SUSQUEHANNA STEAM ELECTRIC STATION
PROPOSED LICENSE AMENDMENT NO. 285
FOR UNIT 1 OPERATING LICENSE NO. NPF-14
AND PROPOSED LICENSE AMENDMENT NO. 253
FOR UNIT 2 OPERATING LICENSE NO. NPF-22
EXTENDED POWER UPDATE APPLICATION
REGARDING STEAM DRYER AND FLOW EFFECTS
REQUEST FOR ADDITIONAL INFORMATION
RESPONSES
PLA-6176

The purpose of this letter is to provide responses to the Request for Additional Information transmitted to PPL in Reference 2.

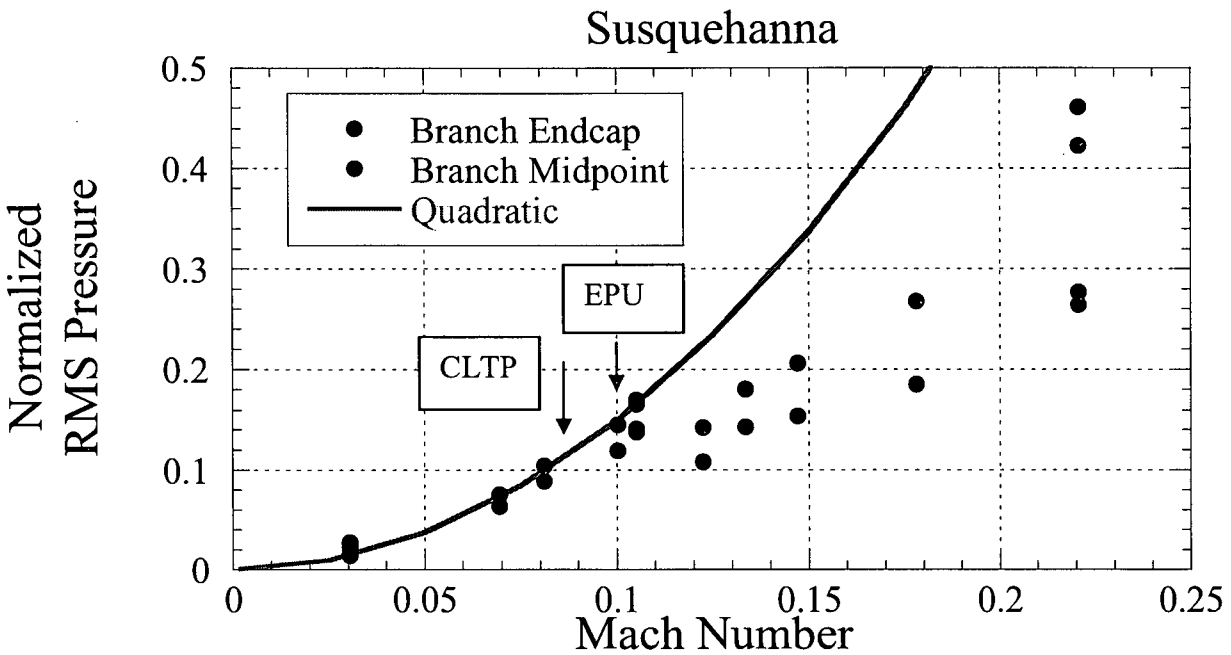
The licensee is requested to provide any available evidence which supports the assumption that pressure amplitude at low frequencies (in particular, the 15 Hz component) will continue to increase proportionally to the square of flow velocity beyond OLTP.

In addition, the 1/5th scale model testing performed by CDI, and documented in CDI Report 05-32 (Appendix 1 of Attachment 10 –Reference 1), suggests that the magnitude of the 15 Hz component will actually drop above EPU Mach number (see attached Figure 7-1).

Figure 9-1 - Pressure data collected on main steam line A (upper location) at Susquehanna (converted from strain gage data), prior to application of coherence to reduce noise. Top: A typical time segment from 30 to 40 seconds is shown; bottom: the PSD.

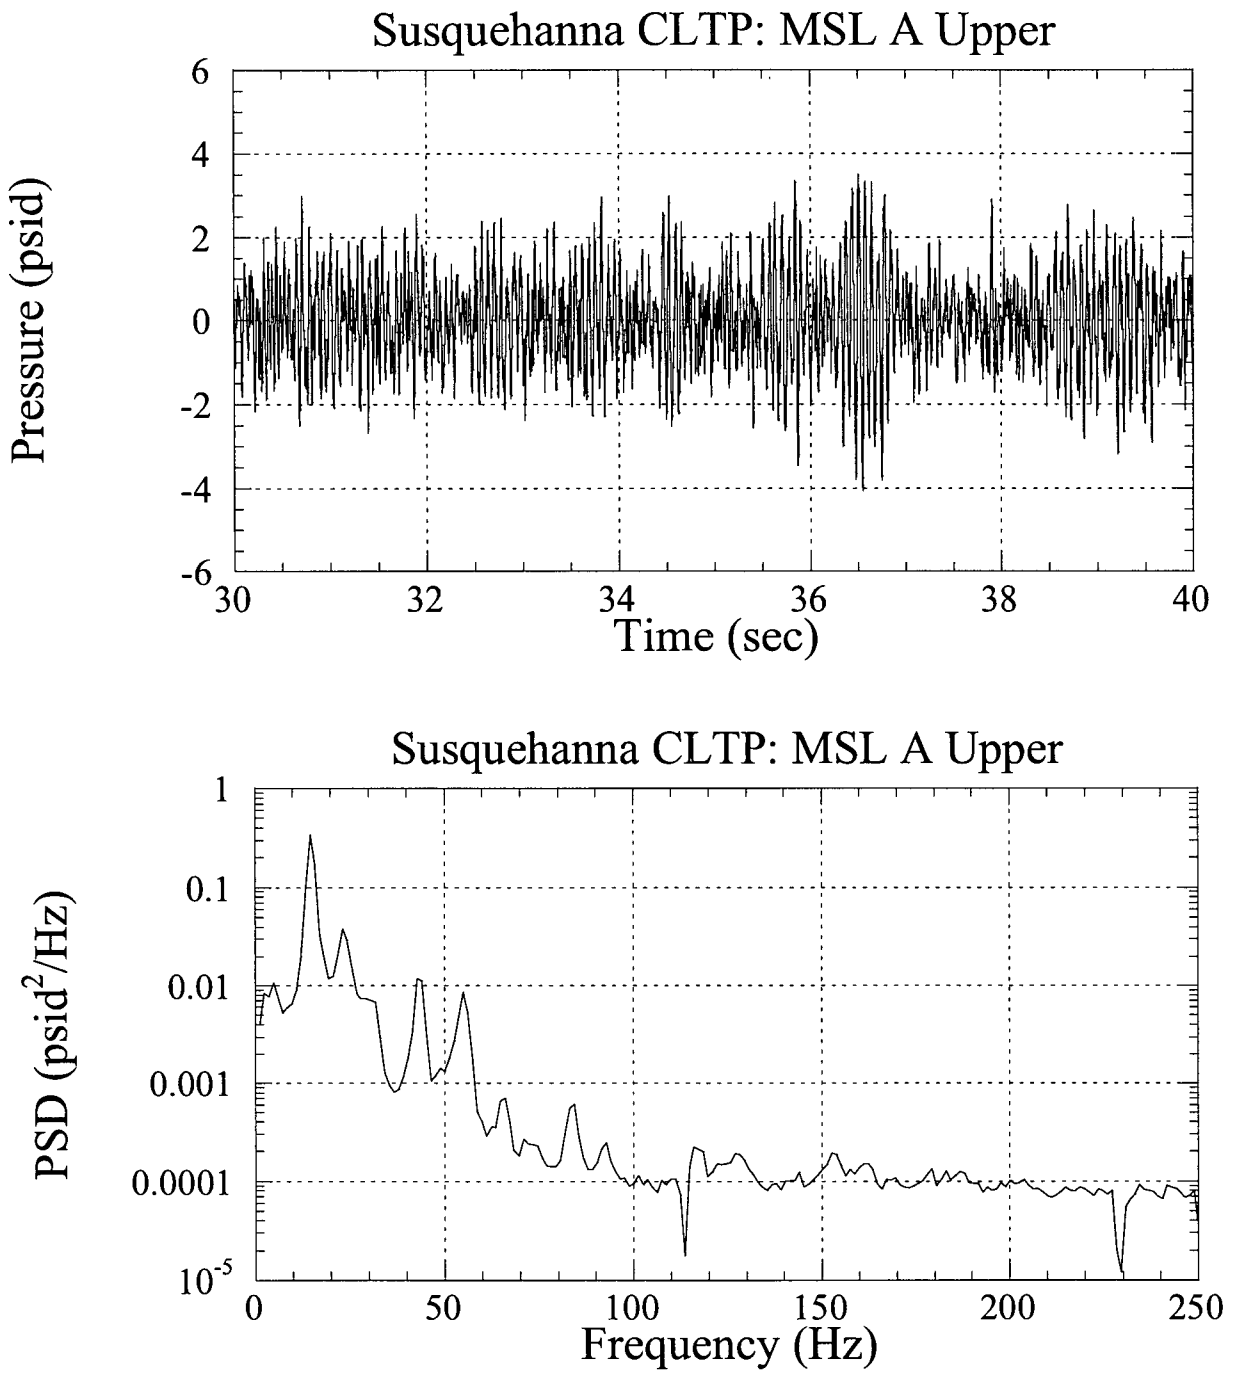
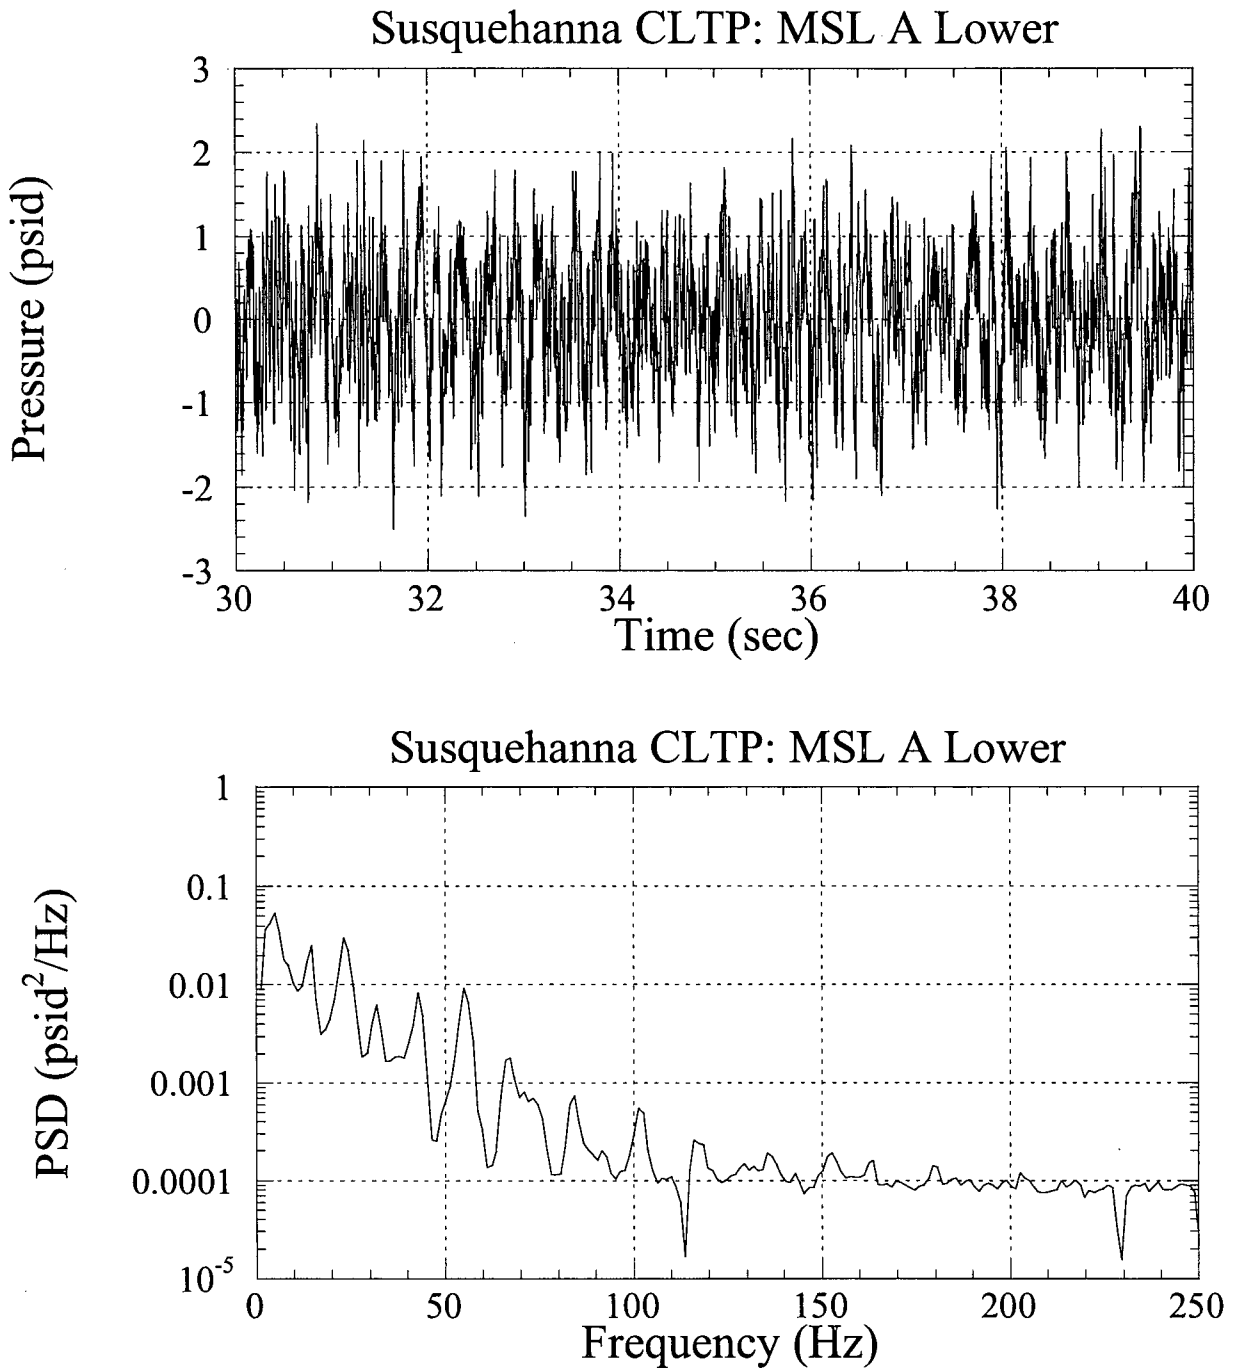
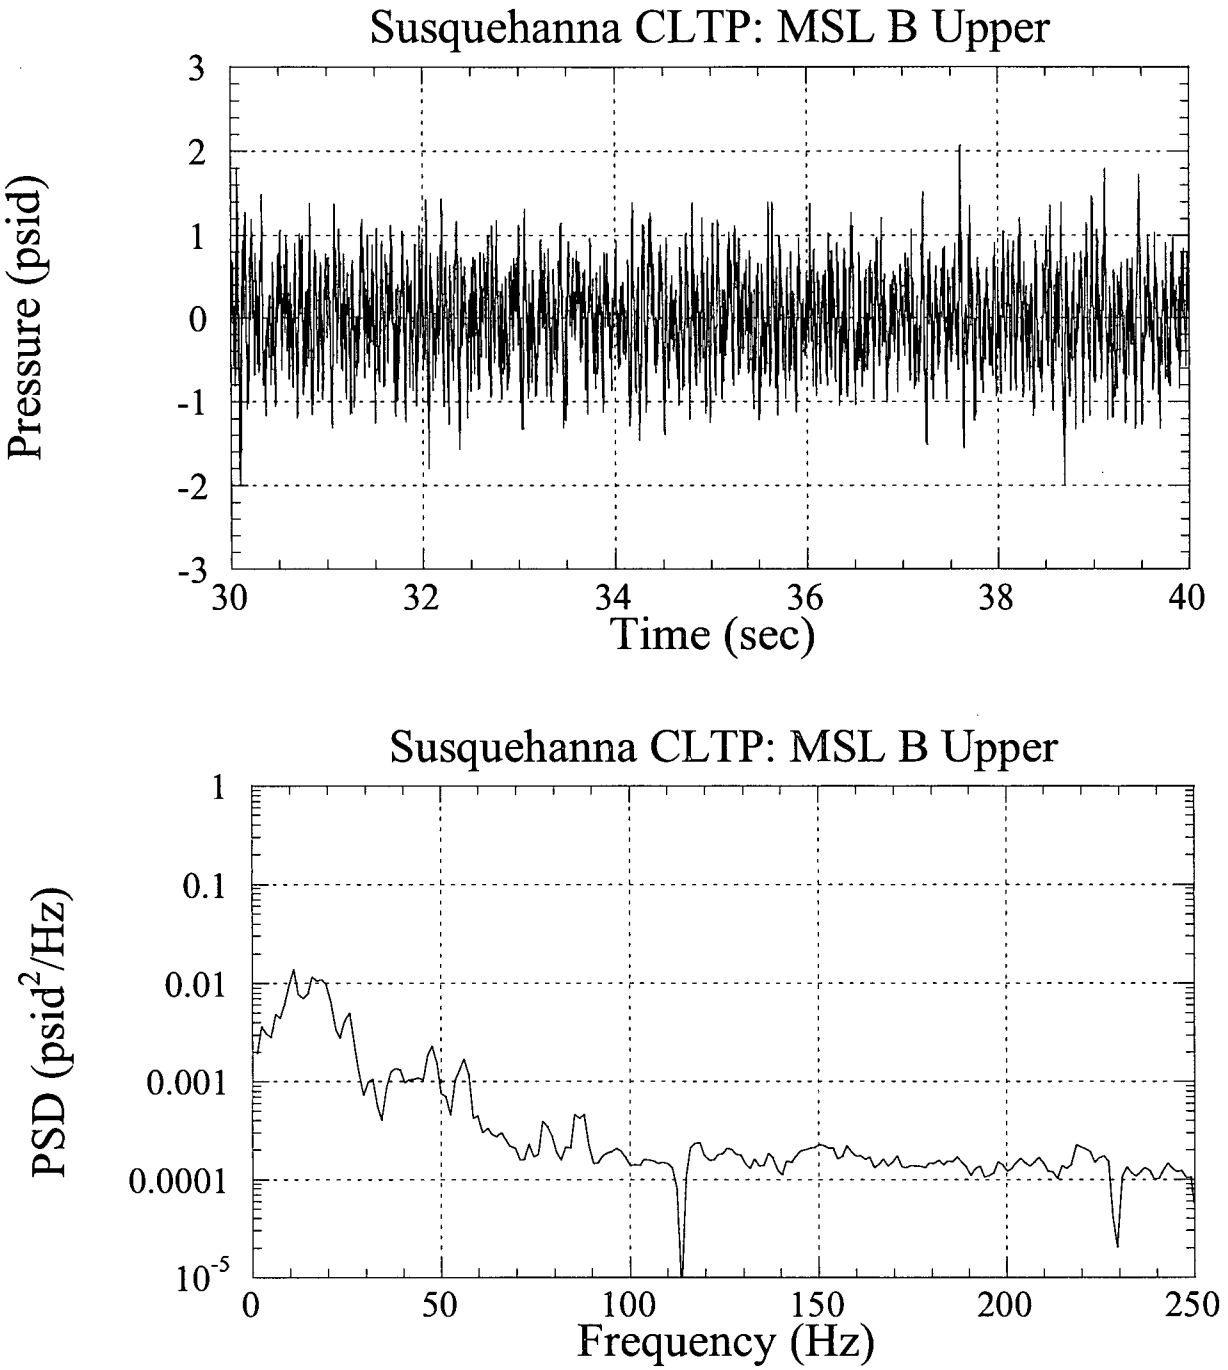
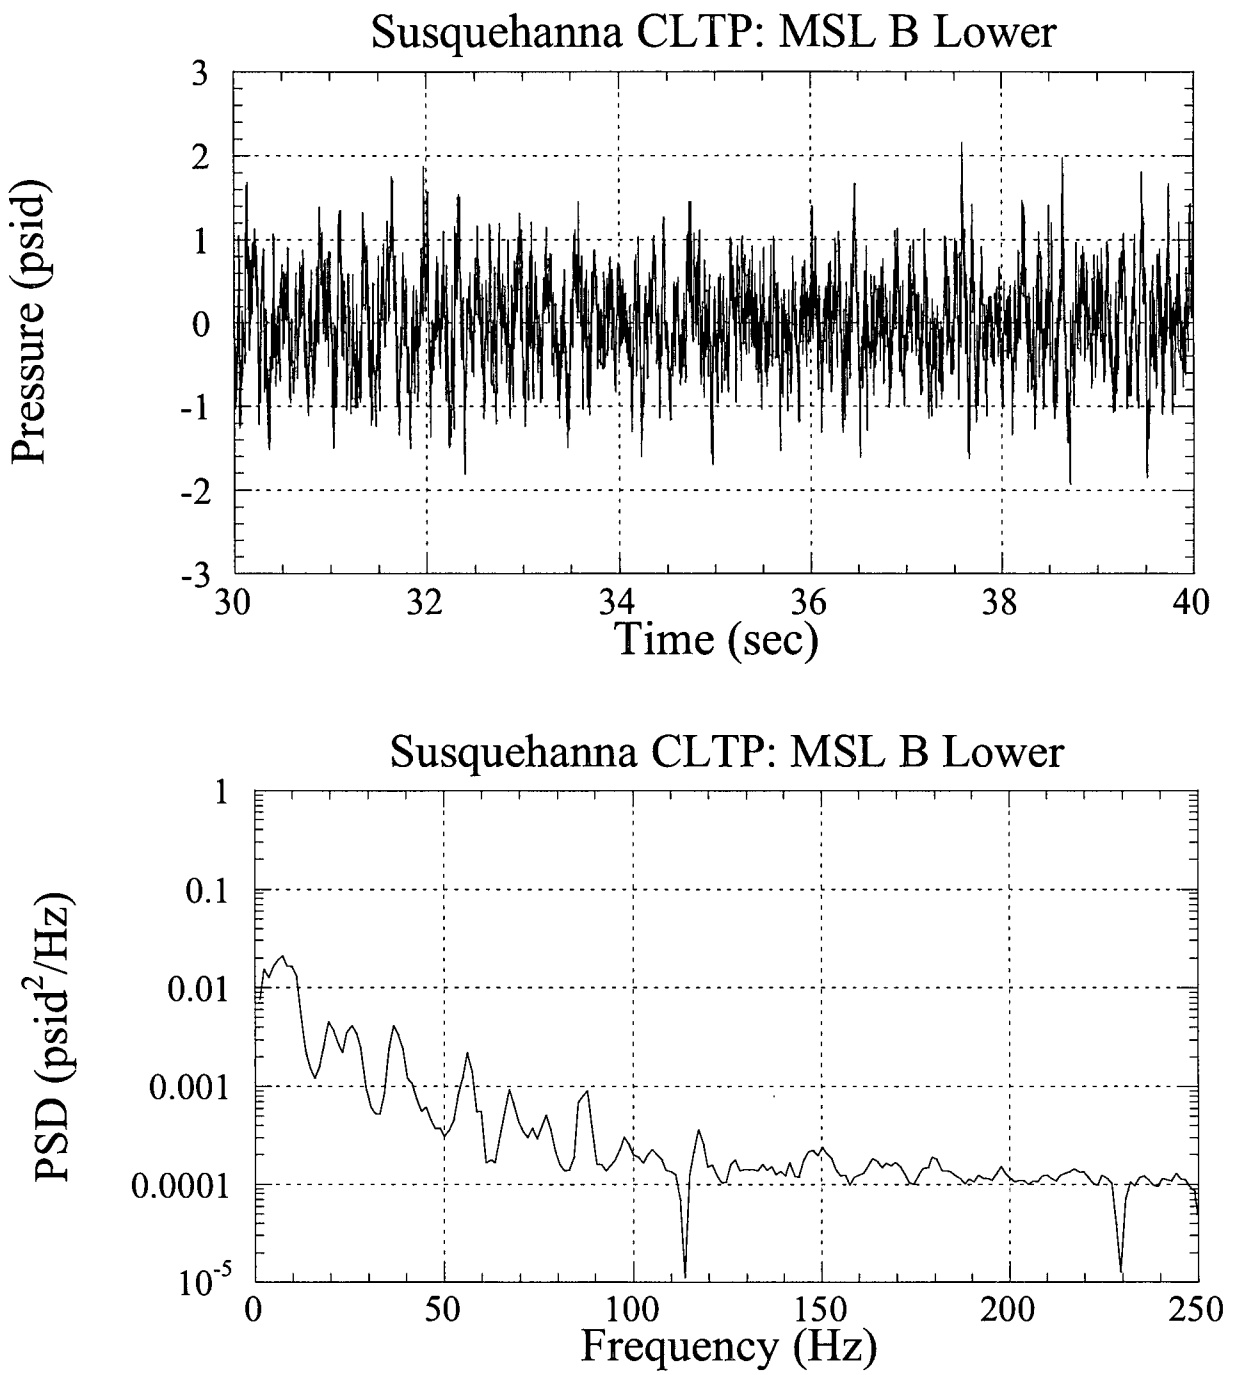
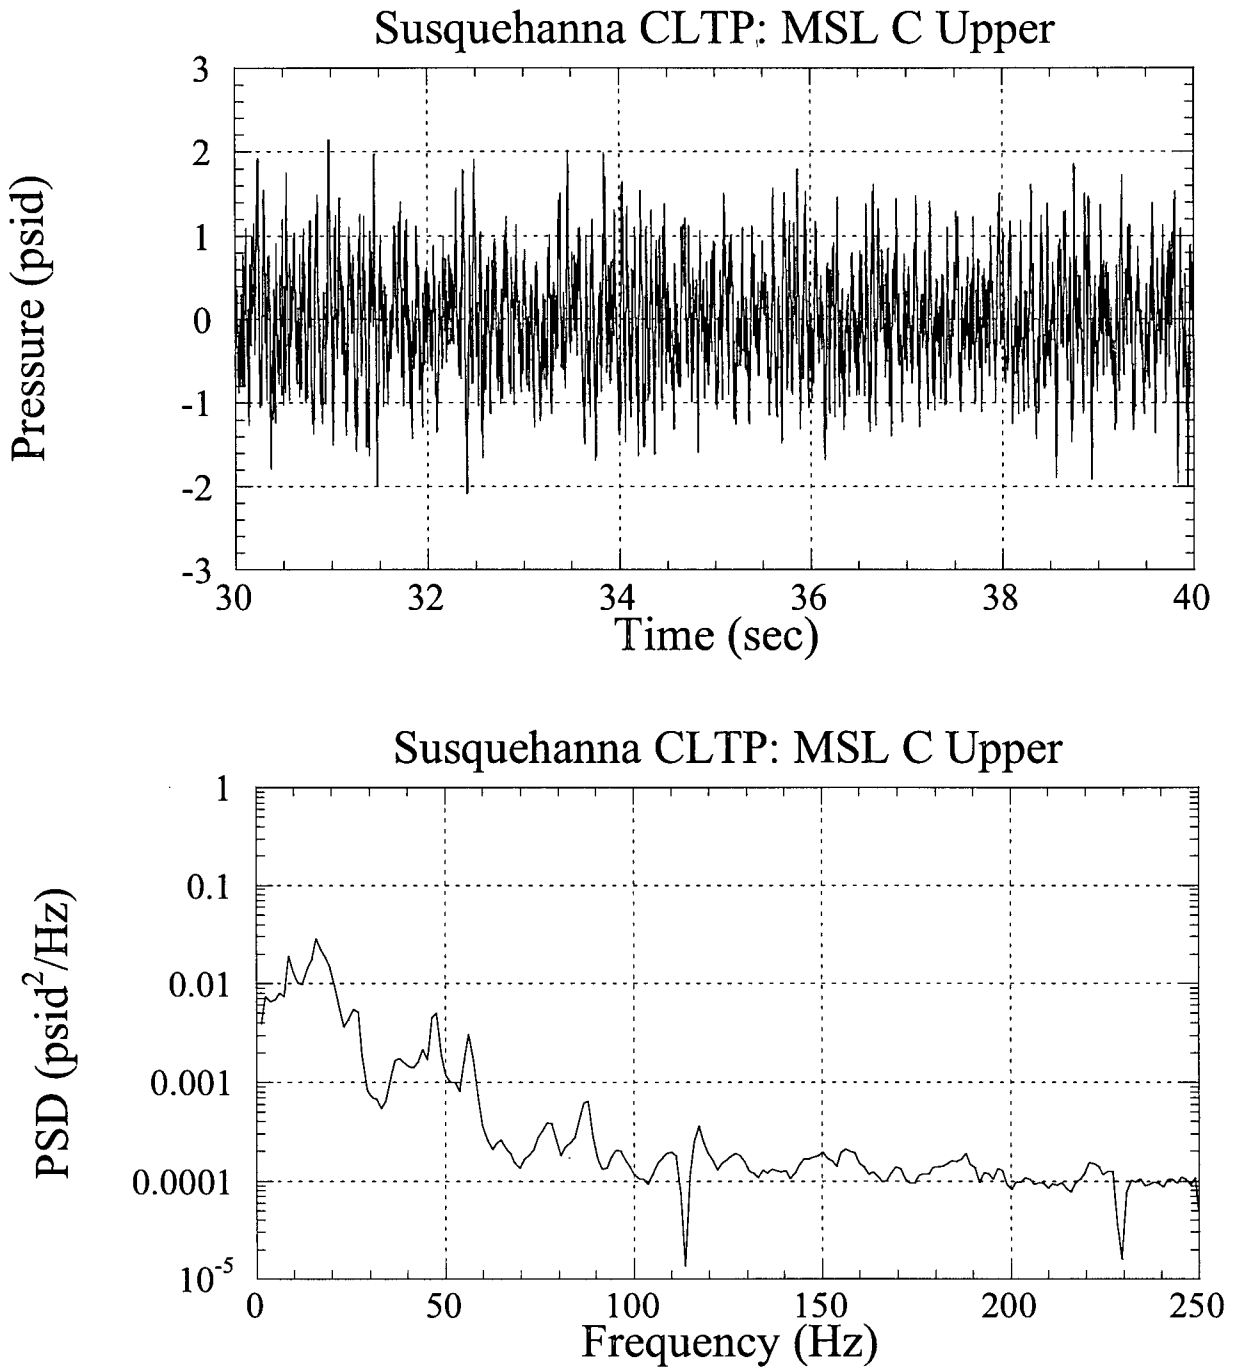
With regard to CDI 06-22, the licensee is requested to provide samples of unfiltered strain gage time signals and power spectral densities. In particular, the provided samples should include the worst case of signal to noise ratio and any other signals experiencing saturation problems or poor frequency response.

The attached Figures 9-1 through 9-8 provide the unfiltered pressure time histories and PSDs at CLTP conditions.
